SERVICE BULLETIN

APPLICABILITY: 2018-19MY Crosstrek
SUBJECT: A-Pillar Trim Cover- Design Change

NUMBER: 12-277-19
DATE: 12/13/19

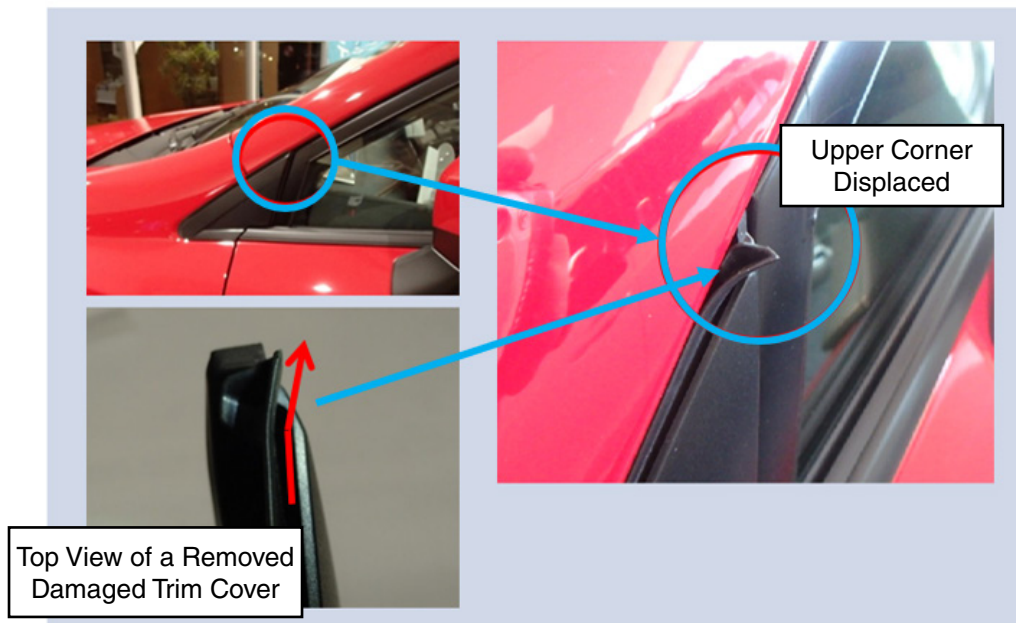
This bulletin describes a design change made to the exterior “A” pillar cover. The change involves use of materials in critical areas having added rigidity along with an extra strengthening rib. These changes will prevent the upper corner portion from being deformed should the leading edge of the front door contact it during opening and closing. The affected area and example photos of what the damaged component may look like are shown below.

The new A-Pillar covers were incorporated into production starting with VIN **KH387837**.
